| <b>Project Title:</b>   | Marsh Landing Generating Station Compliance   |
| <b>Document Title:</b>  | Marsh Landing Generating Station-Petition for Project Modification Approval-Modular Building Installation |

**PETITION FOR APPROVAL OF  
PROJECT MODIFICATIONS  
MARSH LANDING GENERATING  
STATION  
(08-AFC-3C)**

**NRG Marsh Landing LLC**

**UPDATED GENERAL PLOT PLAN**

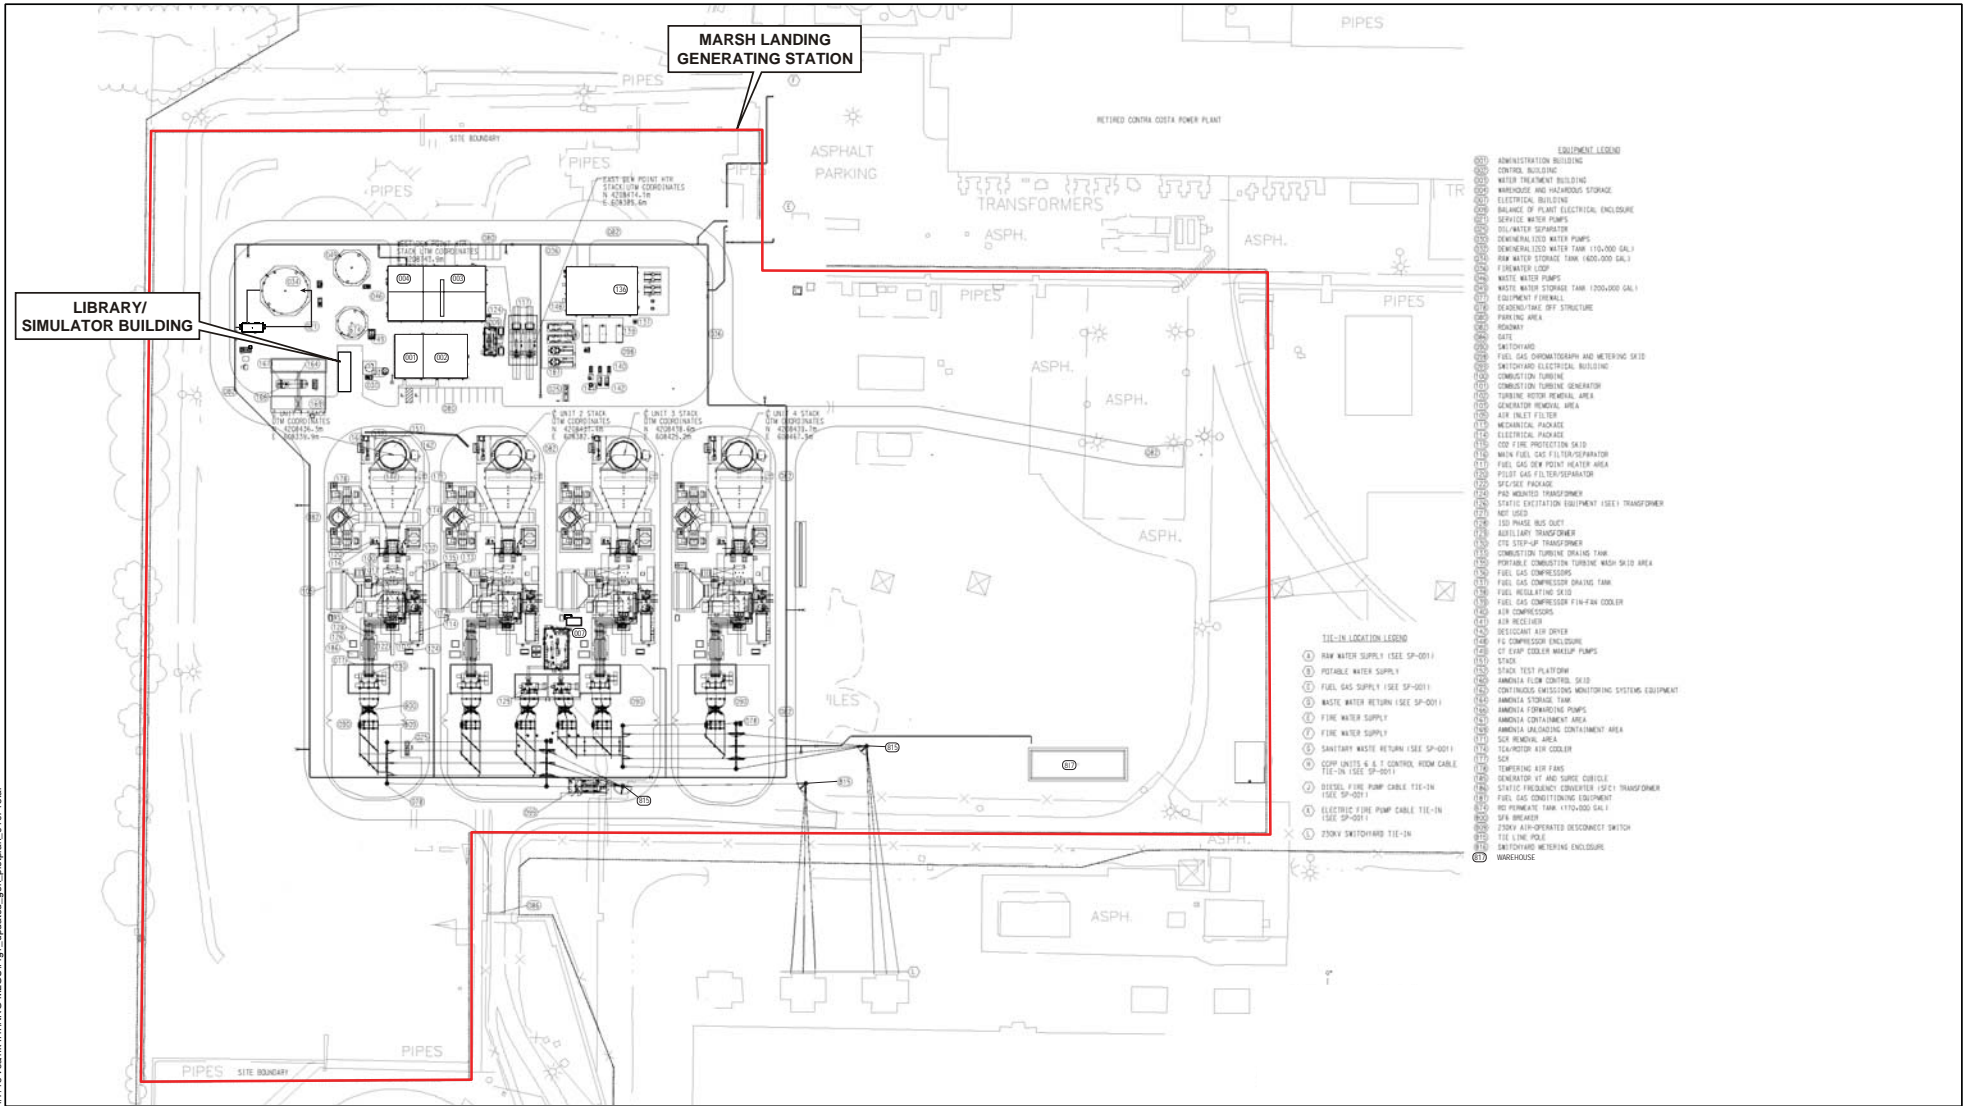
Modifications to the project include a new modular-type building that will provide space for project documents and an operator training computer simulator. The new building will be located near the existing Administration Building, as shown on Figure 1.

NRG Marsh Landing proposes to install a 12-foot by 42-foot modular building on an engineered and seismically designed foundation. The new building will be approximately 504 square feet in area, and 12 feet 9 inches tall. The building will be placed on an engineered pier system, supported by the existing asphalt at grade level. The preliminary design sketches included in Appendix A indicate the building location, access platforms, and utilities.

| L1409B1-NRG; Library  | ADA Ramps Plan View | REV   |

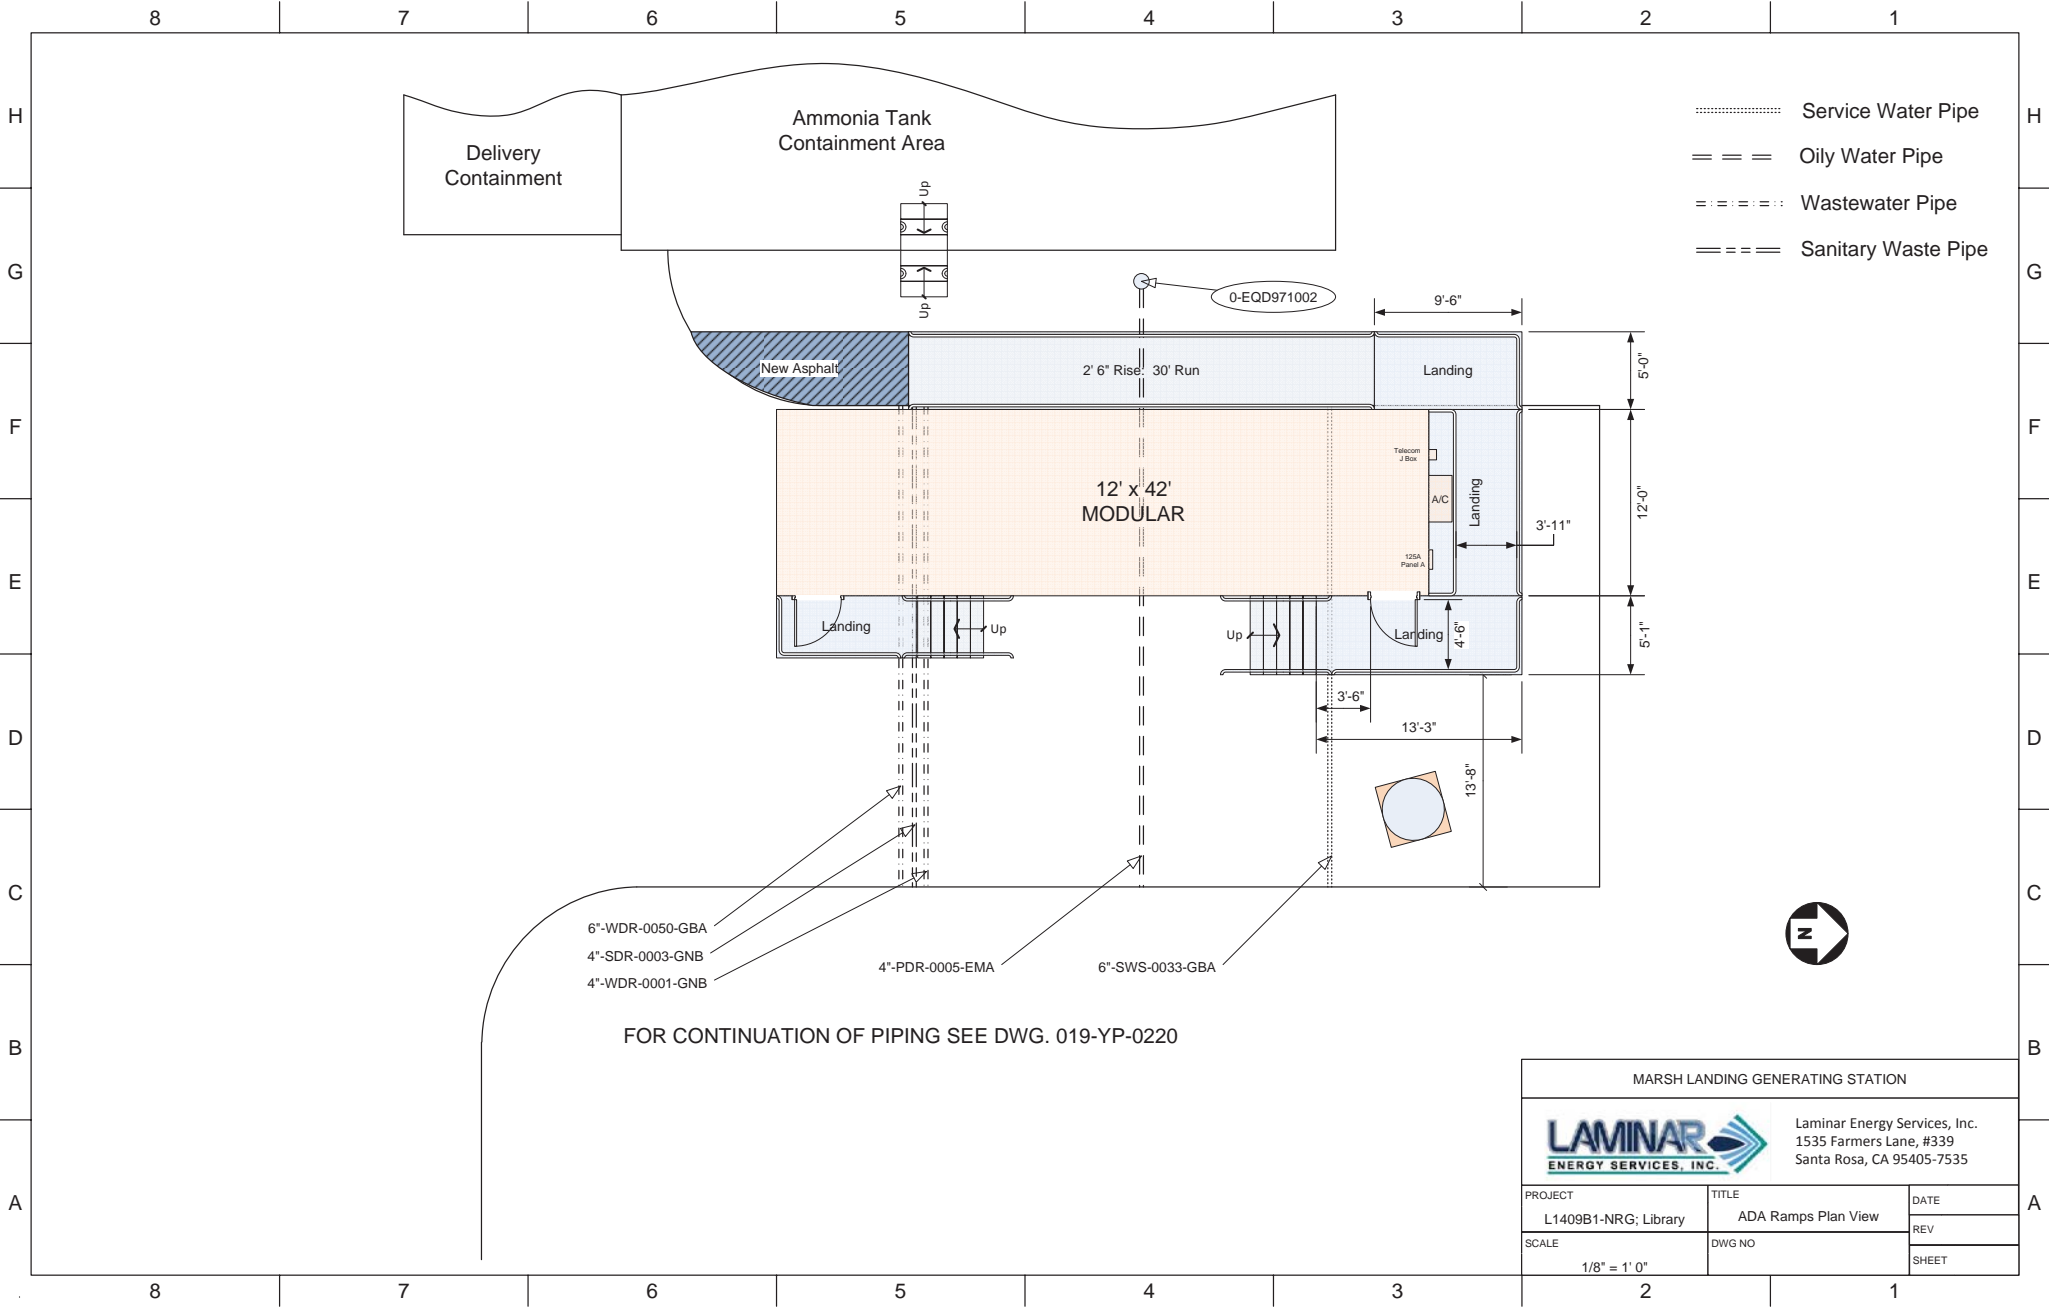
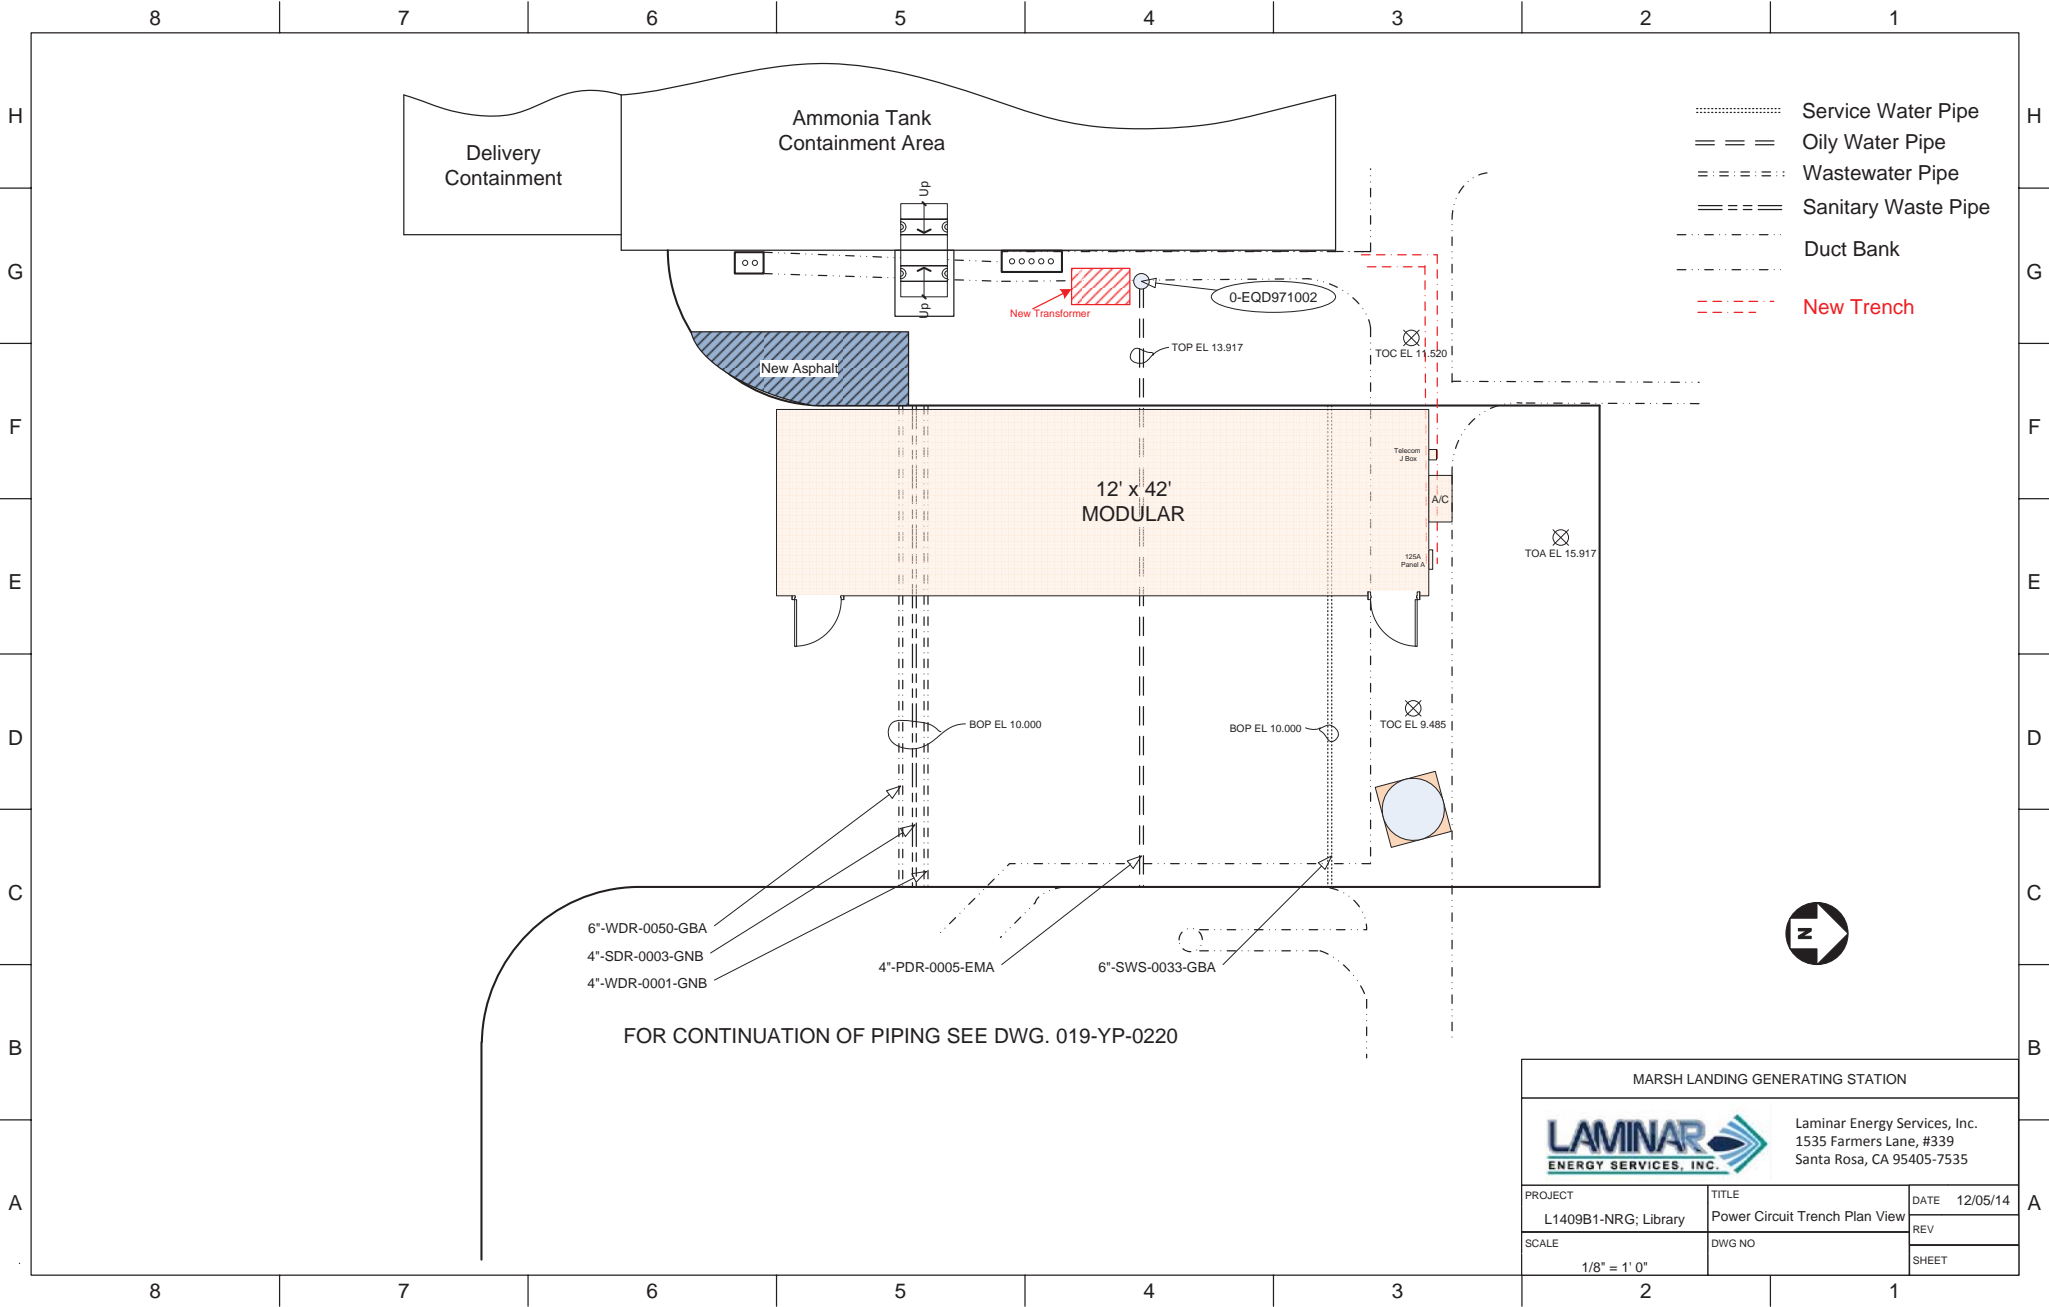
The exterior and interior finishes of the new modular building will be very similar to the existing Administration Building, and will match the existing characteristics of the plant site. Americans with Disabilities Act-compliant access ramps and platforms will be provided, as shown on the sketches included in Appendix A. The access ramps will be structurally engineered, permanent, and of a quality commensurate with the aesthetics of the existing building access ways.

| L1409B1-NRG; Library             | Power Circuit Trench Plan View | 12/05/14  |

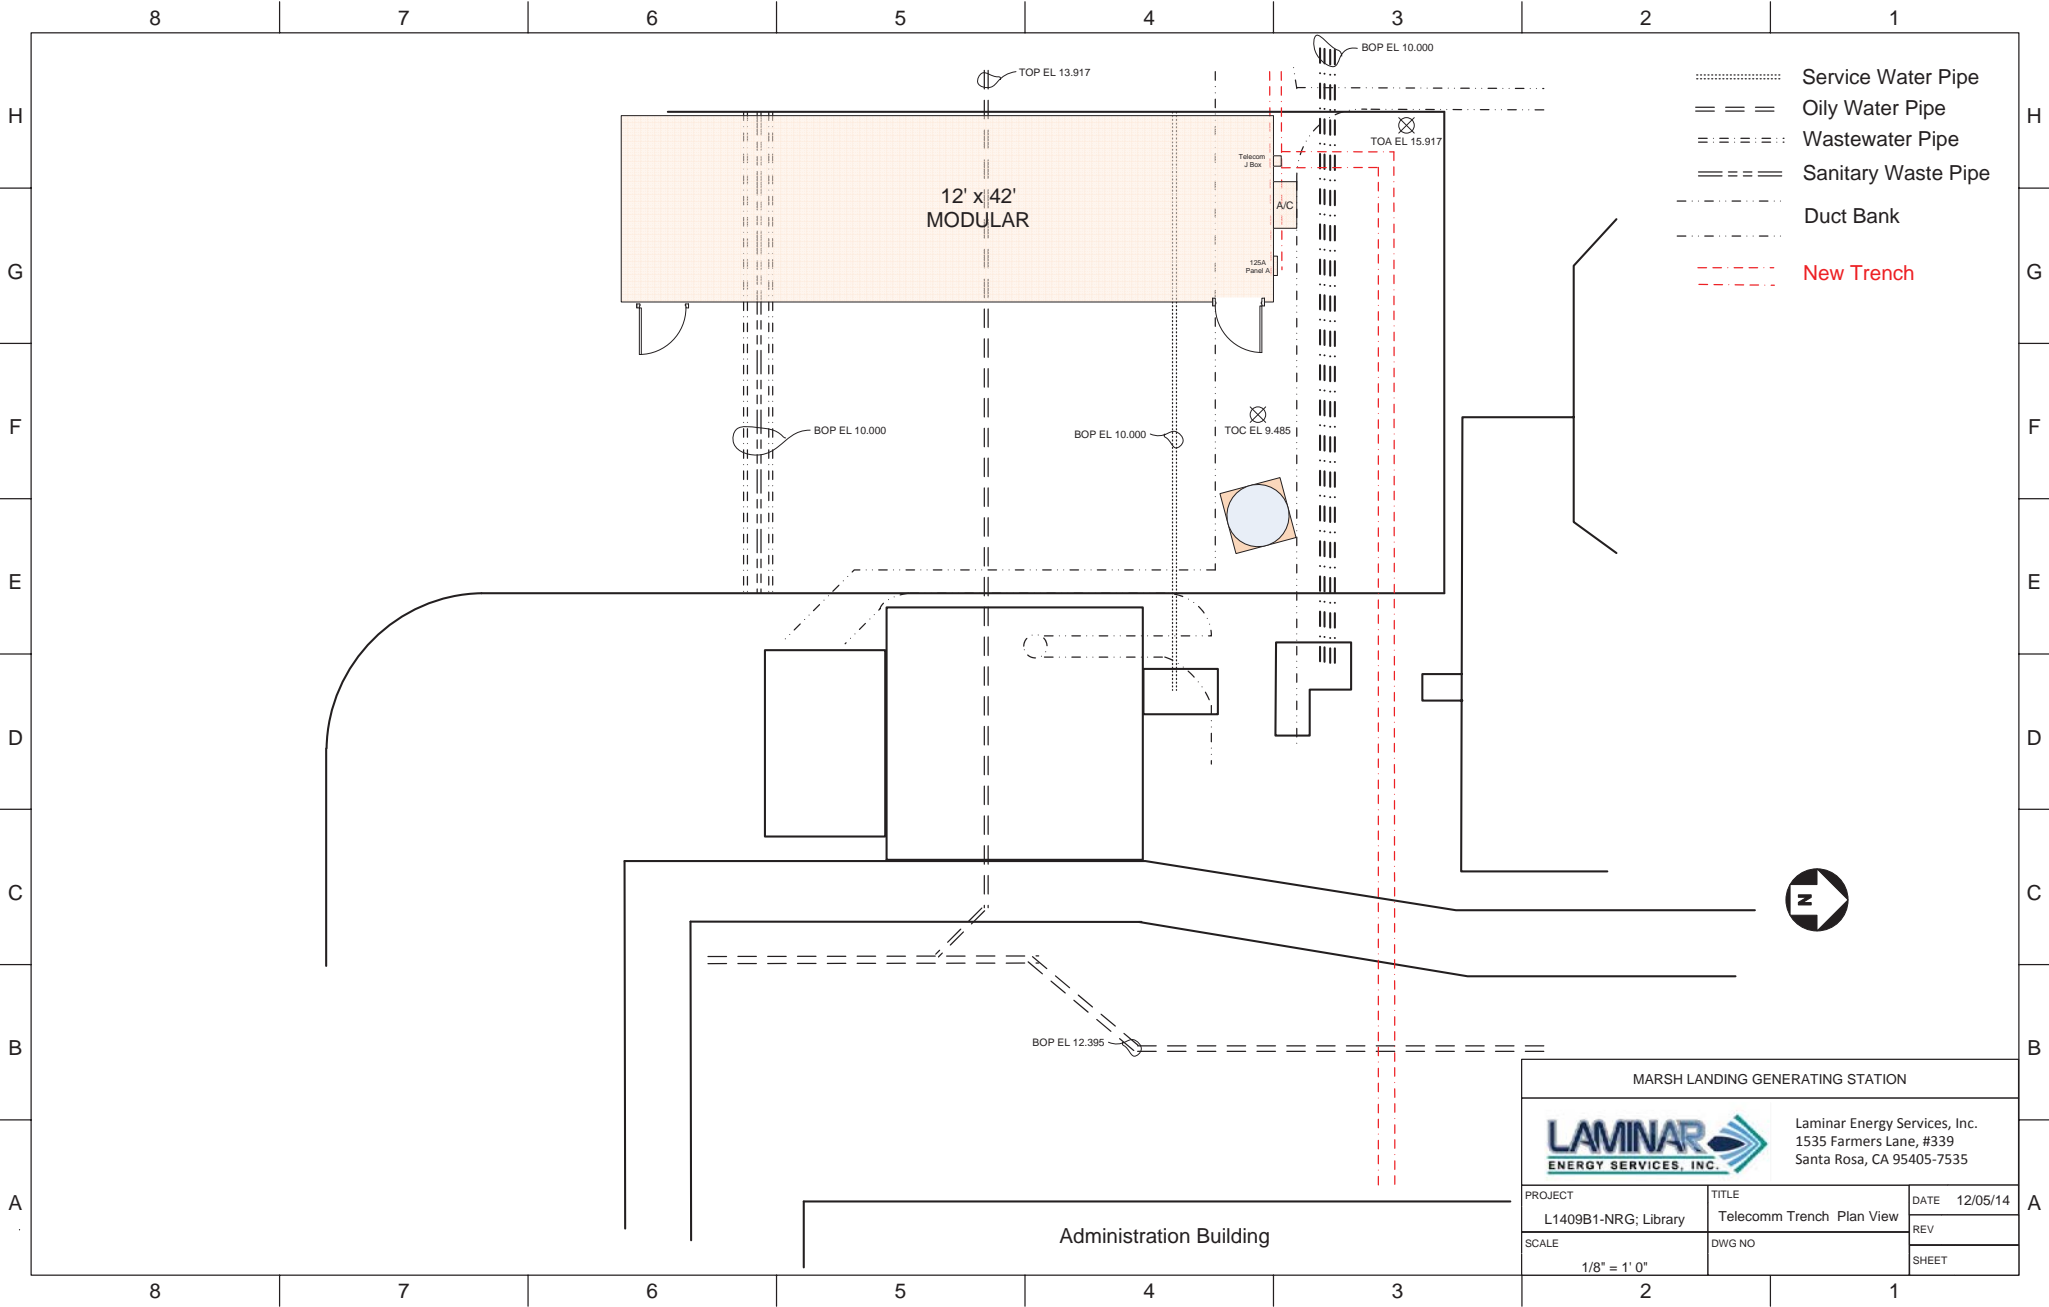
Minimal building utilities are required for the building installation, because it will be adjacent to the existing Administration Building. The required utilities are a 125-amp power service, a small conduit for telecommunications, and grounding for the building to the existing grounding grid directly underneath the proposed building location. The proposed trenching for these services is indicated on the sketches provided in Appendix A. Because bathrooms and a kitchen are already provided at the Administration Building, these facilities will not be included in the new building; therefore, service water piping to the new building is not required. The required fire protection will consist of several wall hanging fire extinguishers; therefore, trenching for an installation into the existing fire water system is not required.

The new building will be placed on an existing asphalt-covered area. The only excavation required will be for utility line trenches from the existing Administration Building to the new building, approximately 20 feet away. Trenches will be approximately 2 to 3 feet deep and 6 inches wide. During trenching, ramps will be installed if the trenches are left open overnight. Trenching will go through areas that are covered in either asphalt or gravel.
